September 14, 2015
ADDENDUM #2 to Bid Documents for the
Hidalgo County Regional Mobility Authority
US 281/BSIF CONNECTOR PROJECT CONTRACT NO. 0220-01-023, Etc.
Advertised August 2, August 9, and August 16, 2015

BACKGROUND ON THE CHANGES TO BID DOCUMENTS

ADDENDUM # 2 - PLAN SHEETS MODIFICATION SUMMARY

SCALE: HOR: 1" = 100' VER: 1" = 10'				SHEET 11 OF 11	
CONT	SECT	JOB	HIGHWAY		
0220	01	023, ETC	US 281		
DIST	COUNTY		SHEET NO.		
PHR	HIDALGO		185

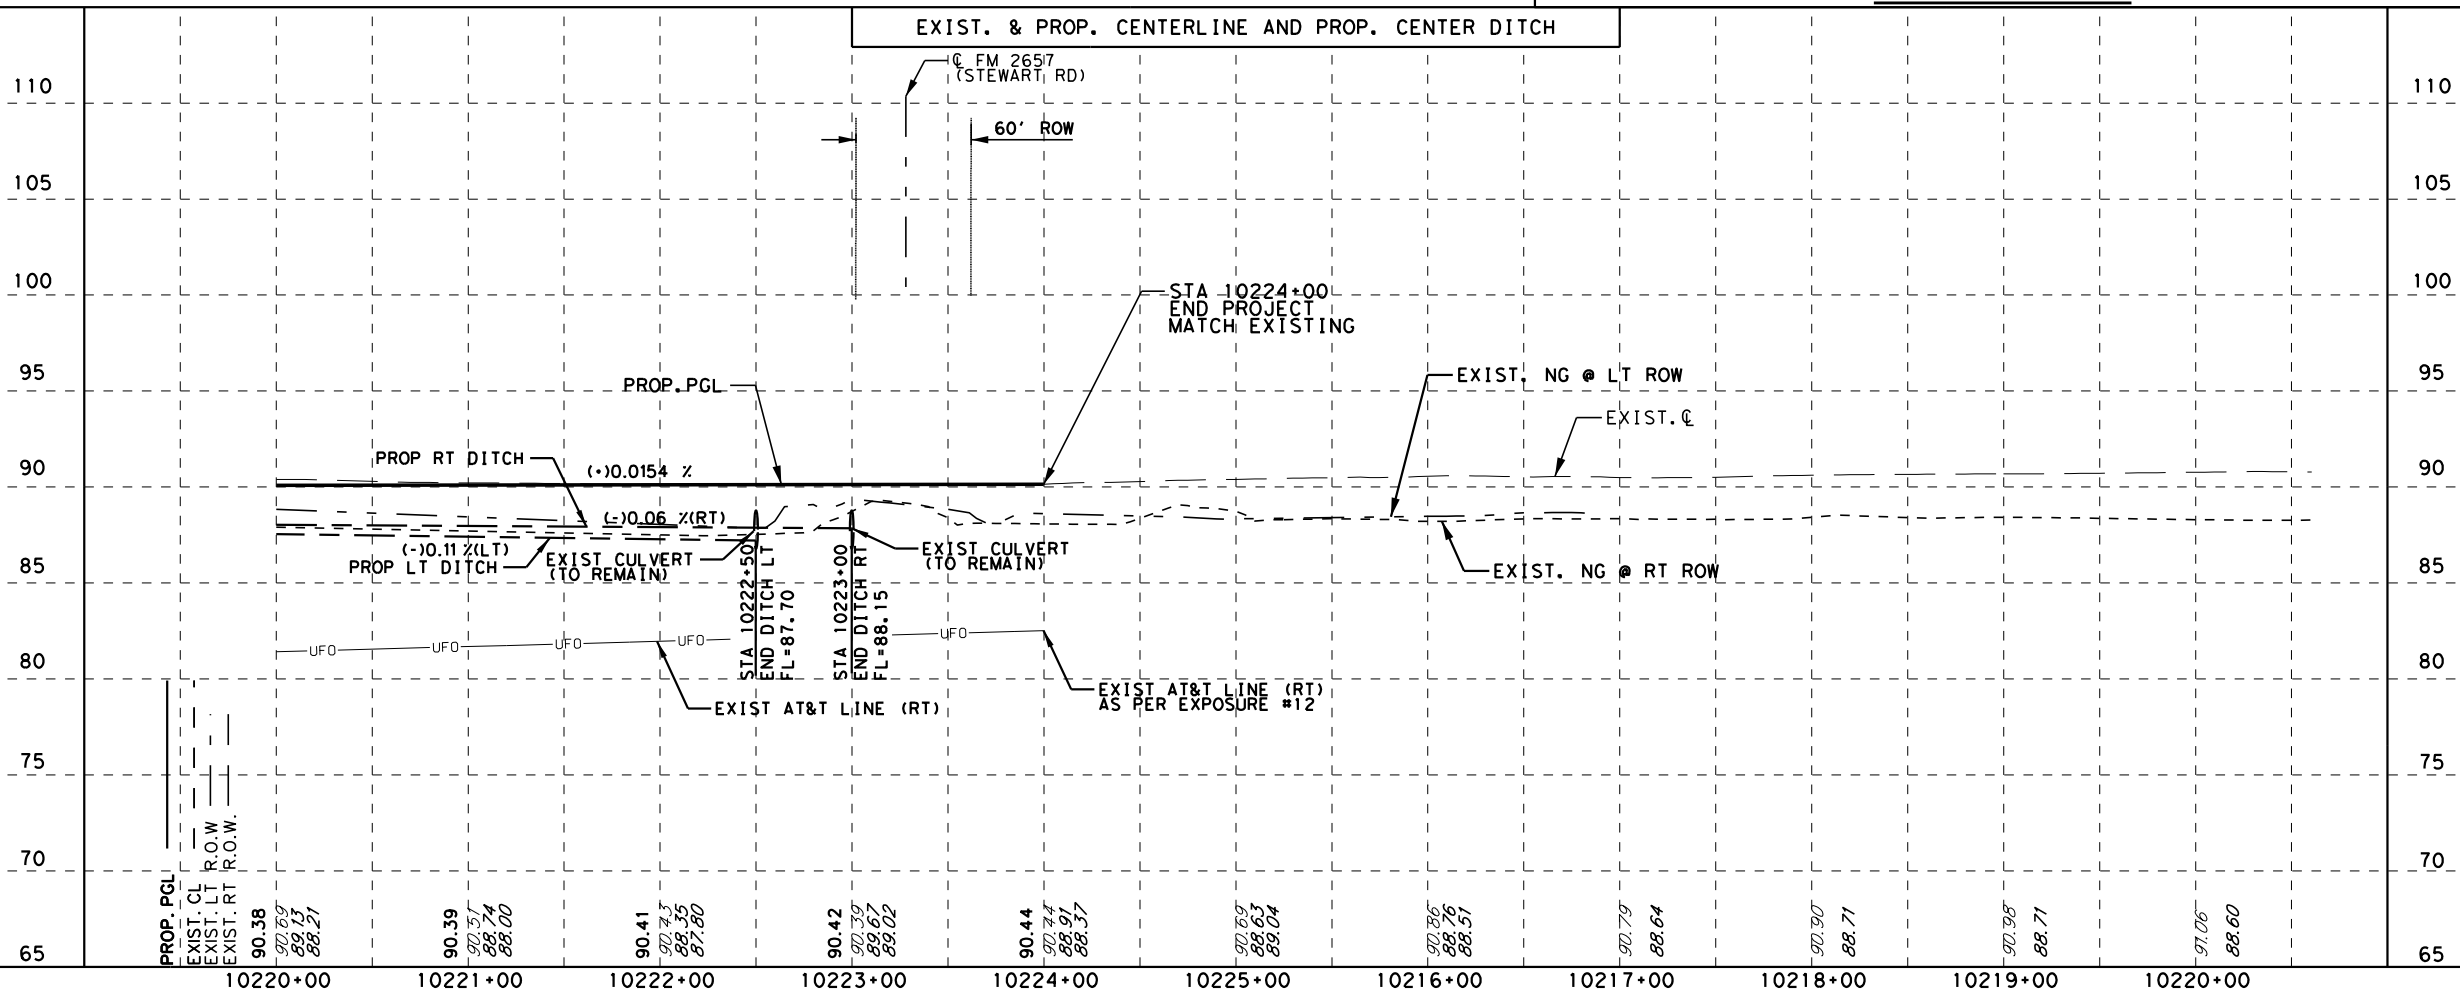
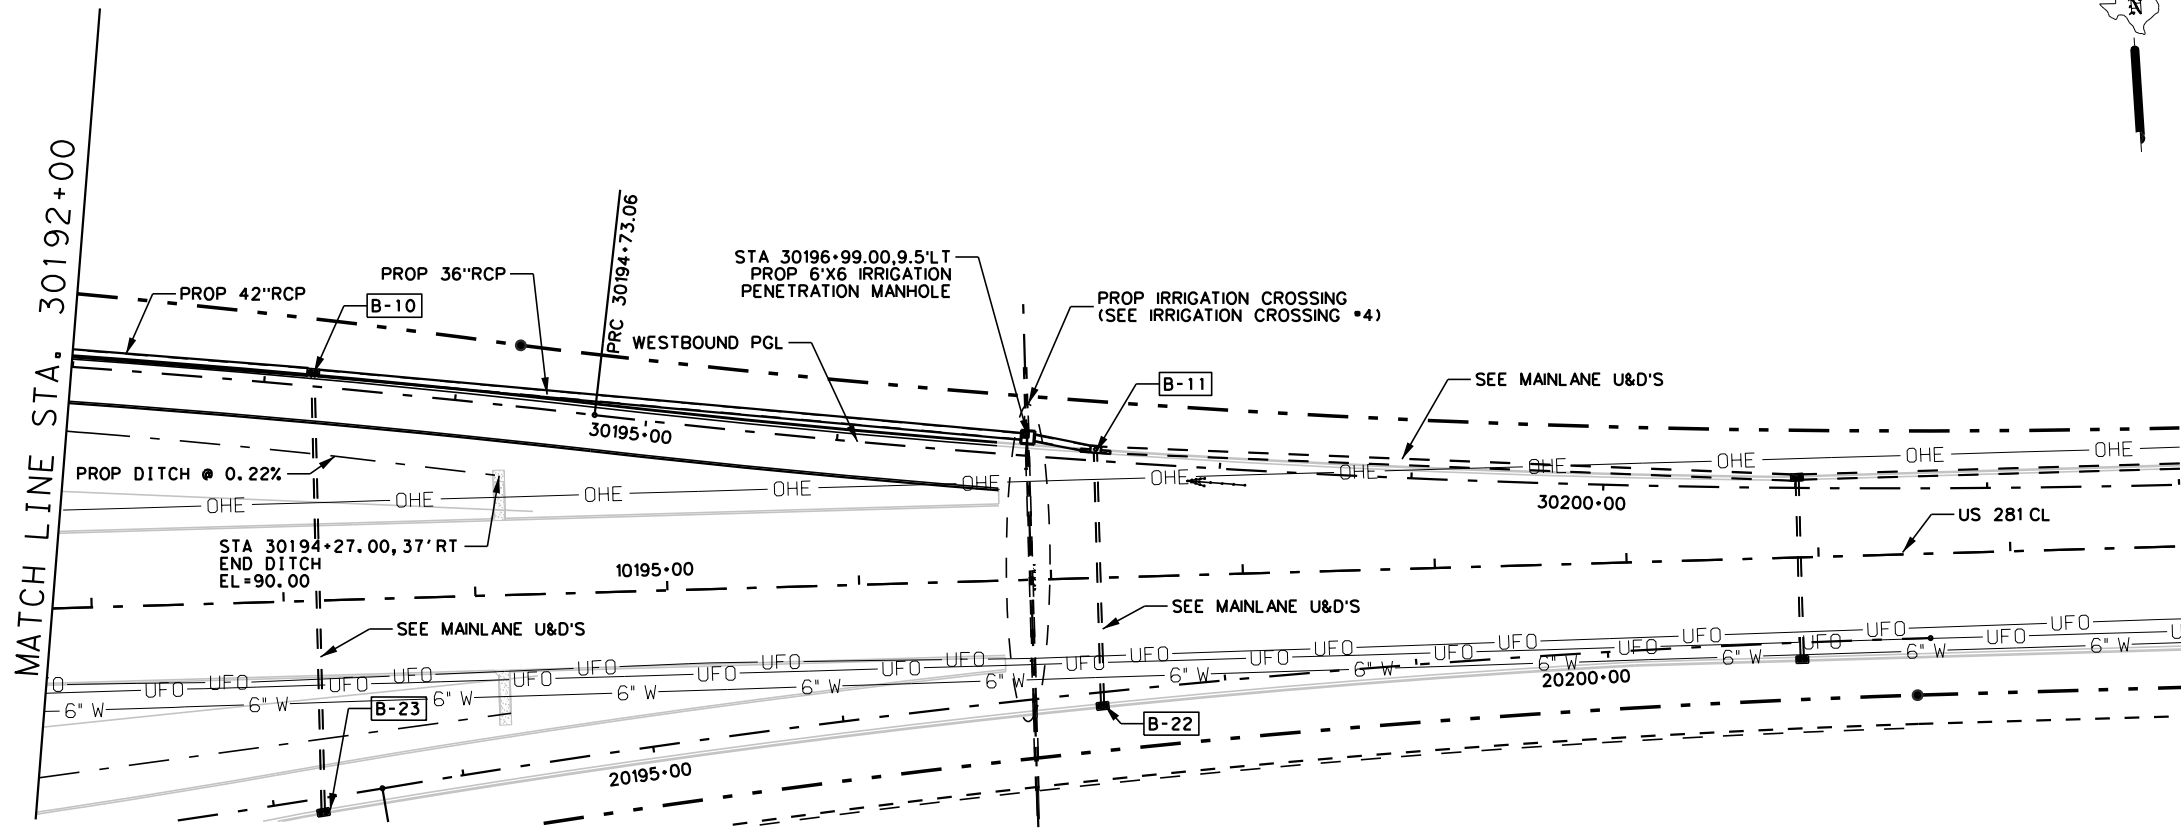
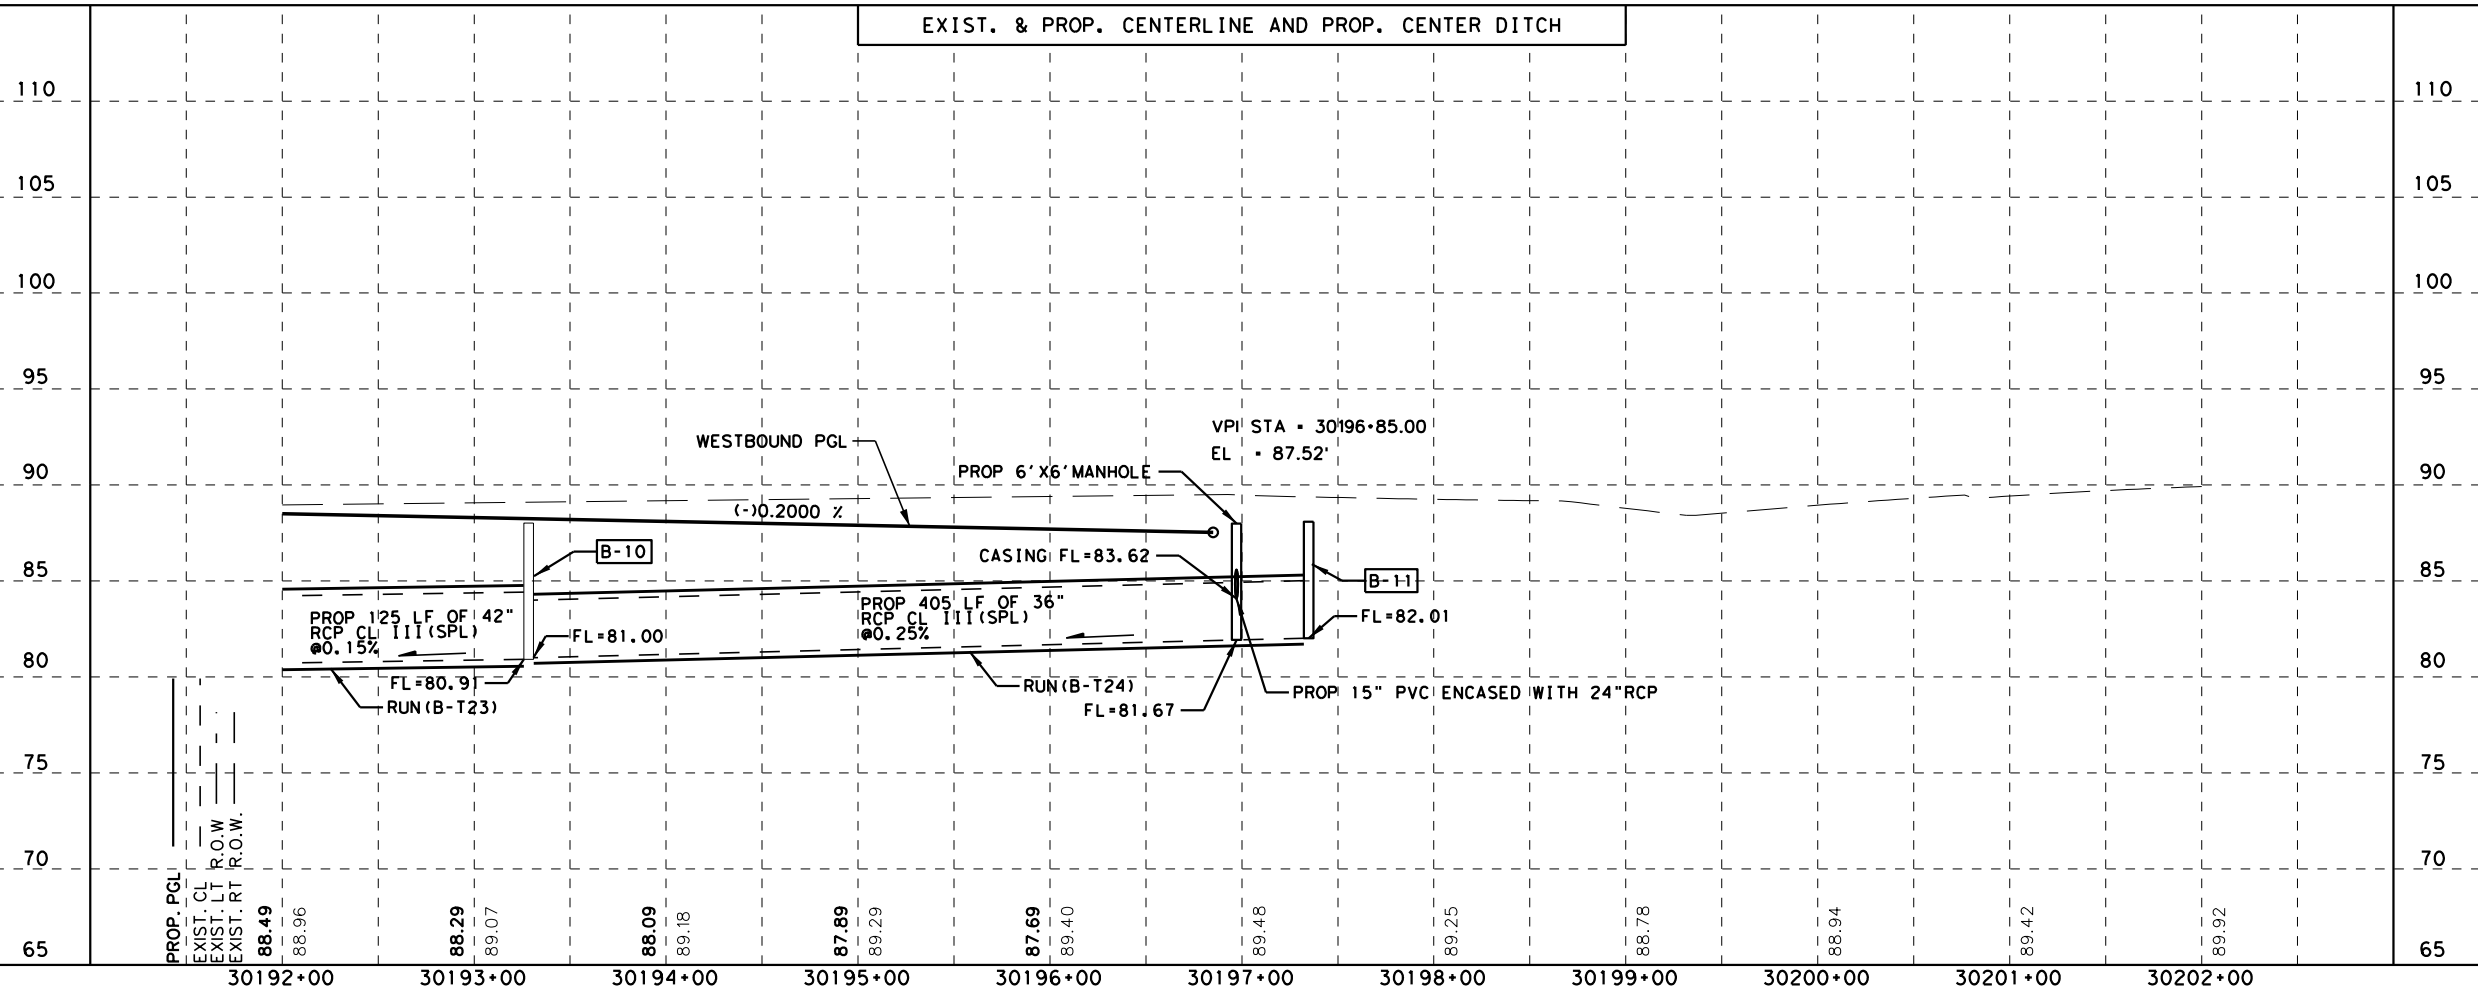
5. There is a “canasta” detail on page 185 without outside dimensions. Does not have locations where it is being used.

Will add dimension and location of use.
